Access Compliance Report

Public Rights-of-Way

Intersection ID: 12017	Main Street: S_I-77_EXIT_10A_RA	Cross Street: W_MOREHEAD_ST	Location: NW
ADA ID: 0B90C410406C	Ramp Type: Perp	Initial Pass/Fail: Pass	Overall Compliance: No
		Severity Score: 20

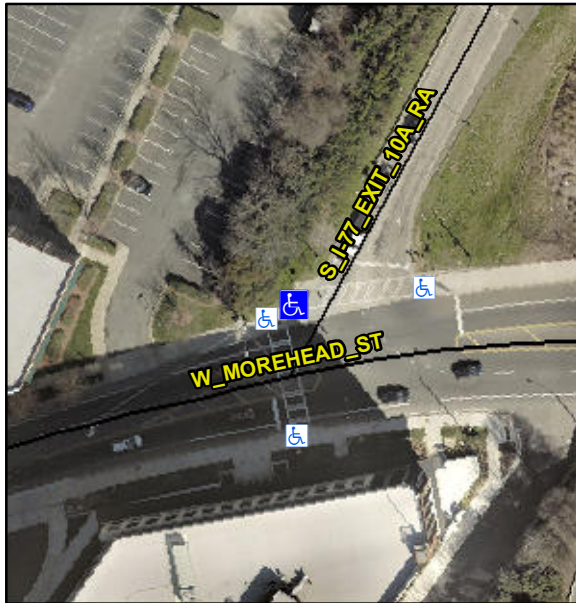
Not Found, R304.2.1, R304.2.2-Perp, R304.3.2-Para, R304.5.3, R305

Remove & Replace Entire Ramp.
